### MHFD Referral Review Comments

<b>Project Name:</b>	Parkdale PUD Amendment No 3
<b>Location:</b>	NWC of E County Line Rd and E Baseline Rd

**Subject: Parkdale PUD Amendment No. 3 – PUDA-001342-2021**  
**Town of Erie, Boulder County, CO; CGS Unique No. BO-22-0001-2**

# PARKDALE P.U.D. OVERLAY MAP, AMENDMENT NO. 3

DATE SUBMITTED: 09.17.2021	
REVISION NO.	DATE
1	11.02.2021
2	12.22.2021
3	
4	
OEO, LLC 7353 SOUTH ALTON WAY CENTENNIAL, CO 80112 303.770.9111	
SCALE:	JOB NO: 0043-1532
N.T.S.	BY: BSS
SHEET 2 OF 3

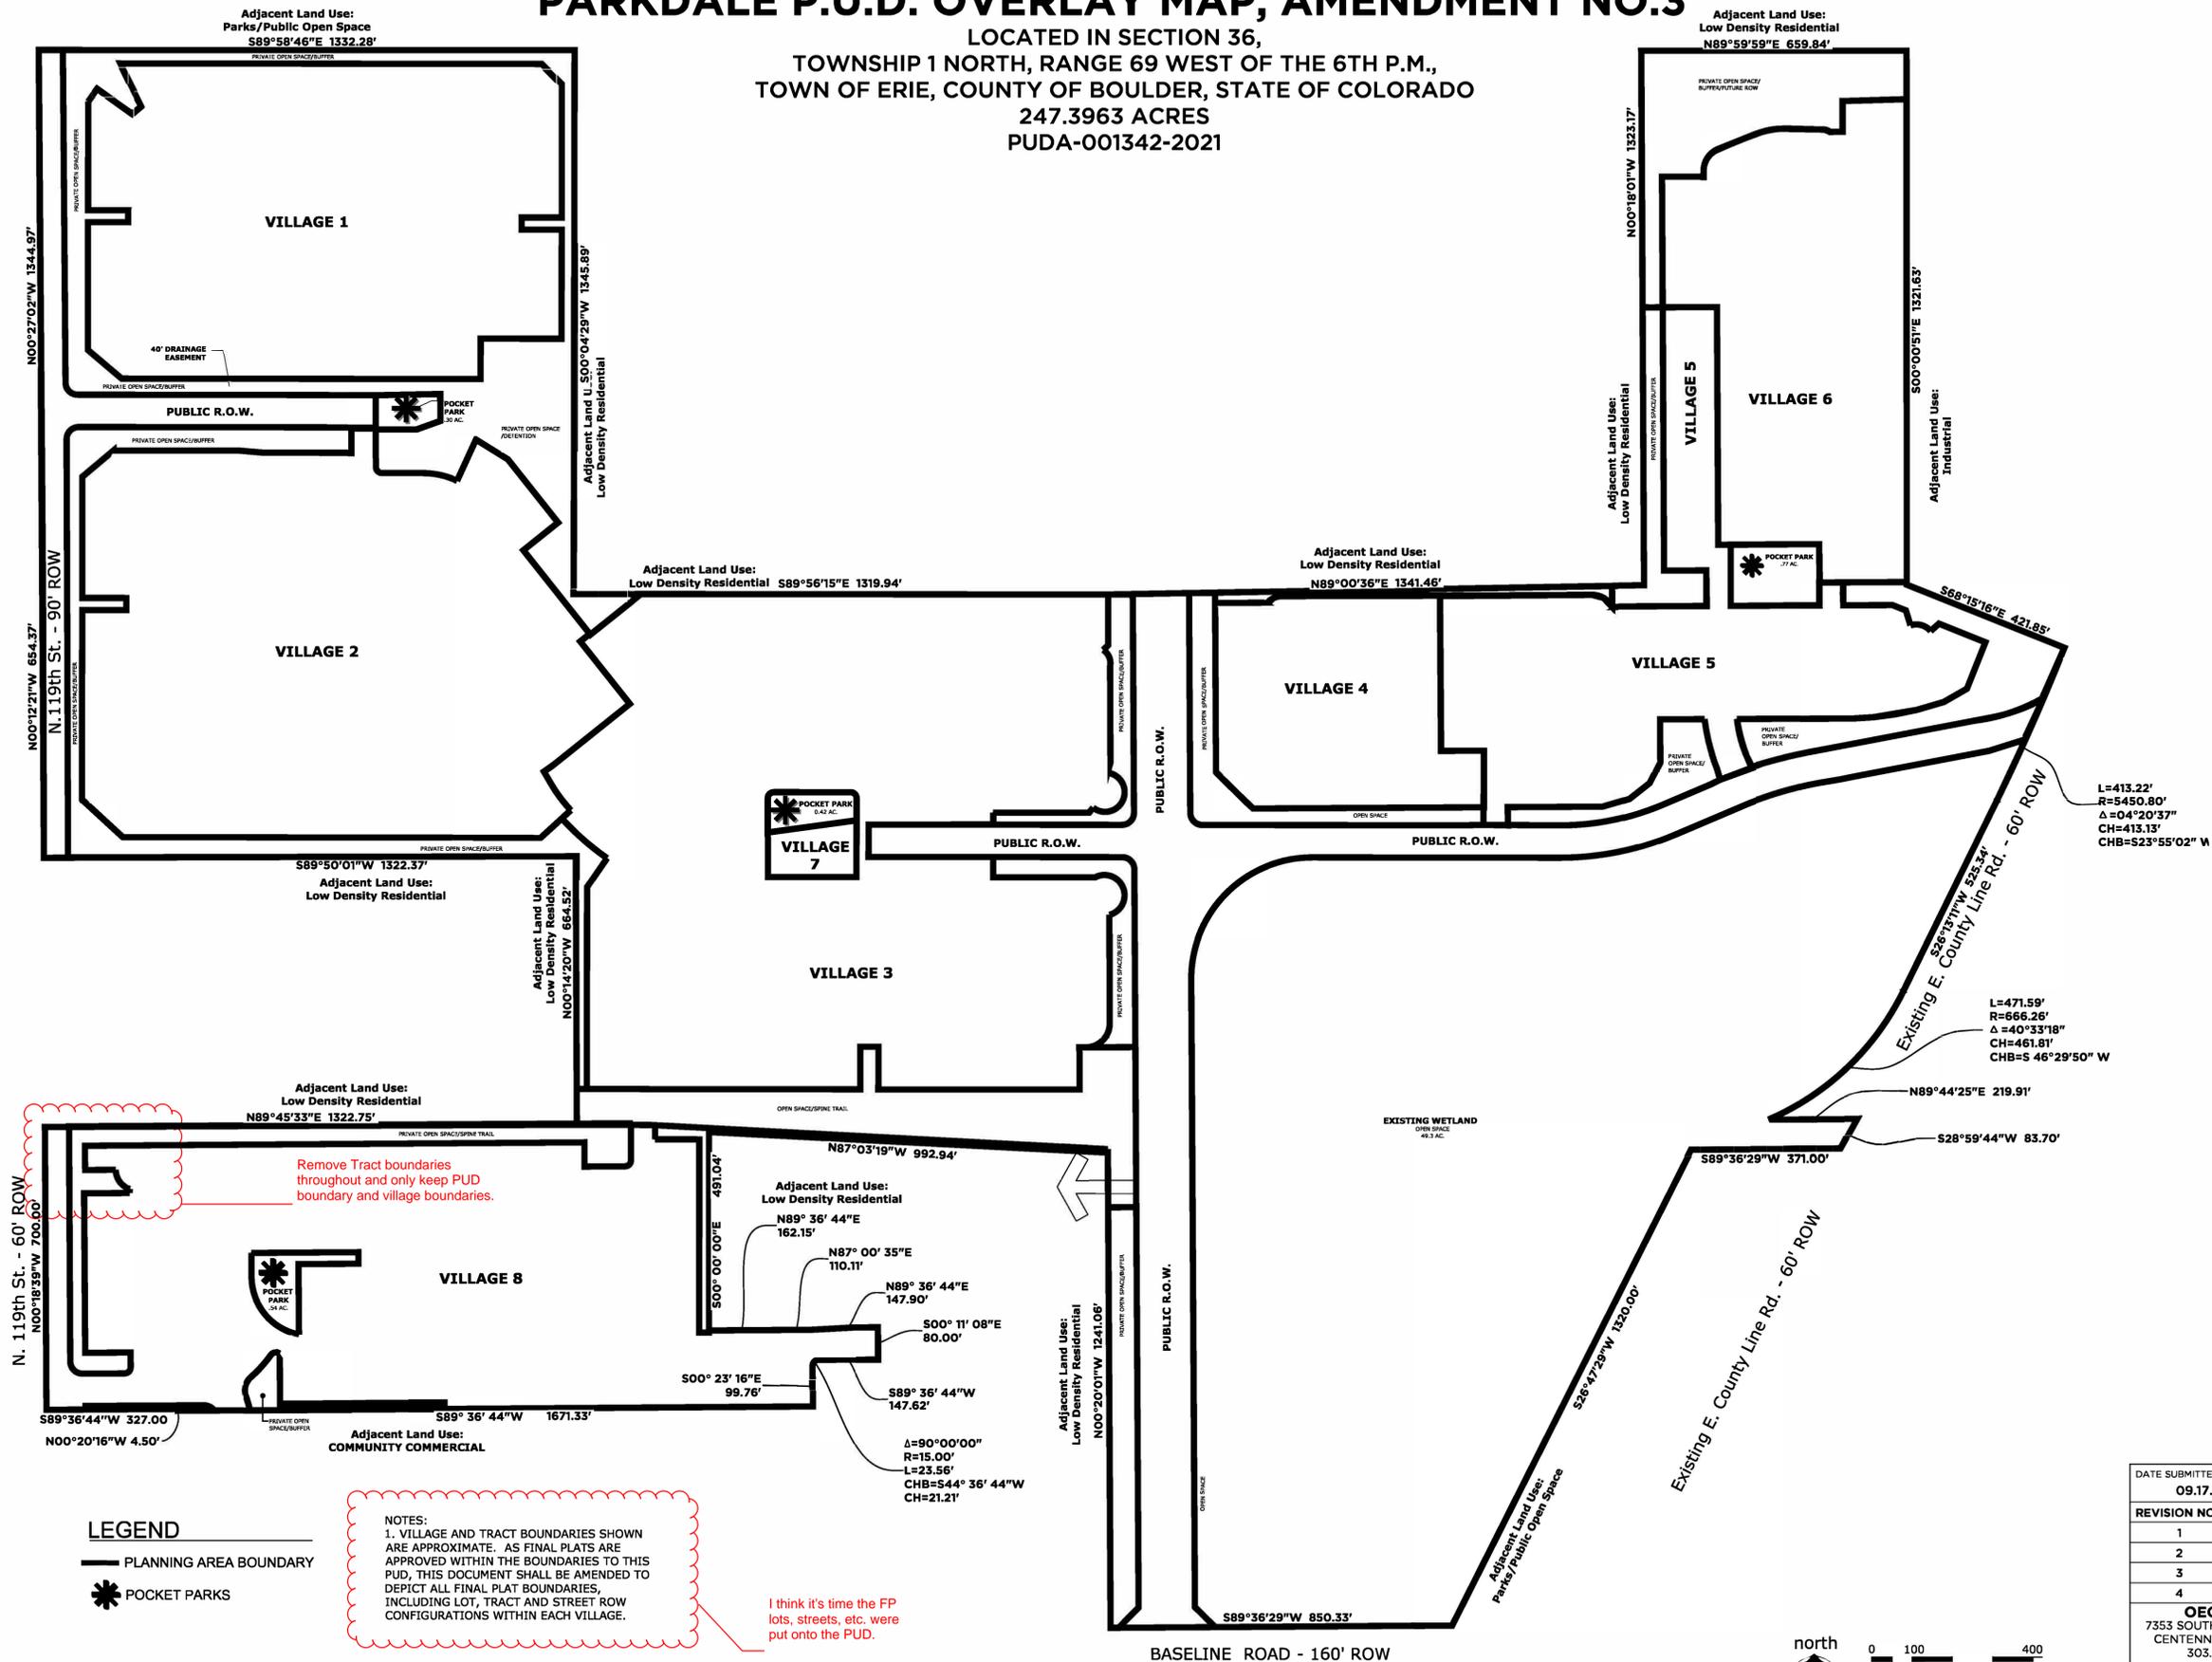
I think it's time the FP lots, streets, etc. were put onto the PUD.
